BCA Design Assessment Report

LAHC –  
Warwick Farm

11-13 Mannix Parade  
Warwick Farm NSW 2170

Project: LAHC Warwick Farm  
 Document Type: BCA Design Assessment Report  
 Our Reference: P220\_065-3 (BCA) LB

Figure 4– Paths of travel to road from fire isolated exits

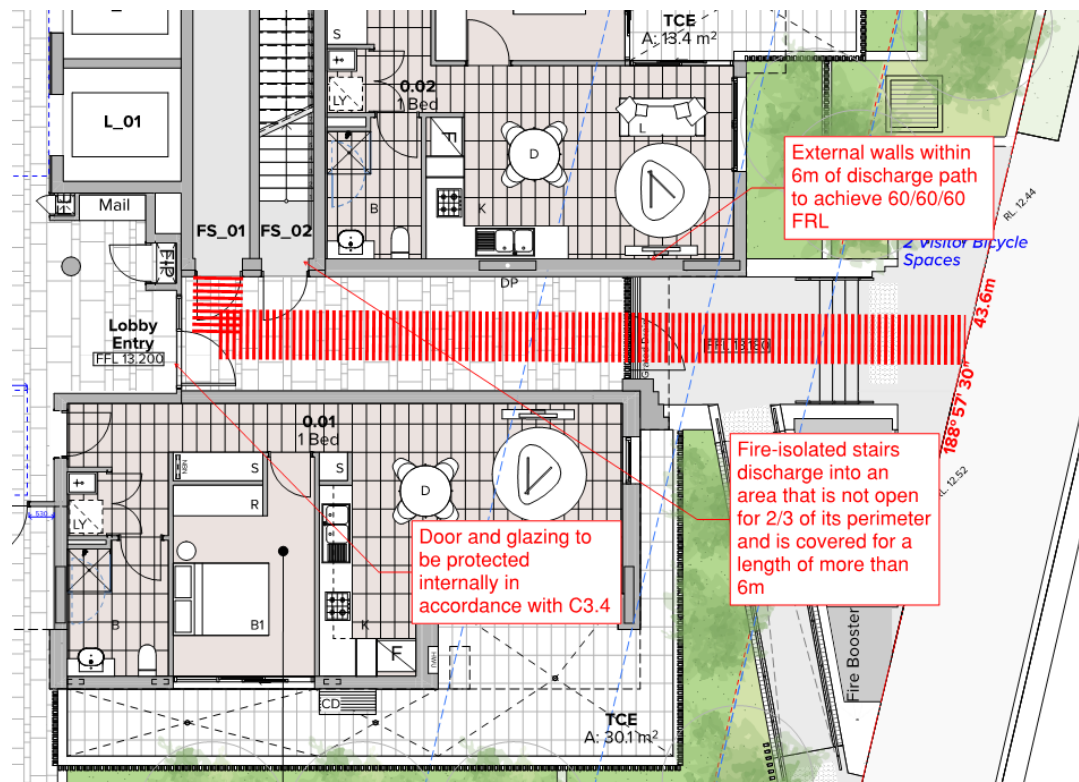
It is noted that the fire isolated stairs serving residential levels and basement both discharge externally and require occupants to pass by within 6m to parts of the external wall (specifically the lobby)

In addition to the above, both fire stairs discharge into a covered area not open for at least 1/3 of its perimeter and does not provide an unimpeded path of travel of less than 6m to the road.

To address the above compliance item the following options are provided:

- (i) Re-configure the discharge from both stairs to not be directed within a non-compliant covered area; or
- (ii) Justify the current configuration via a performance-based solution, demonstrating compliance with the relevant performance requirements of the BCA.
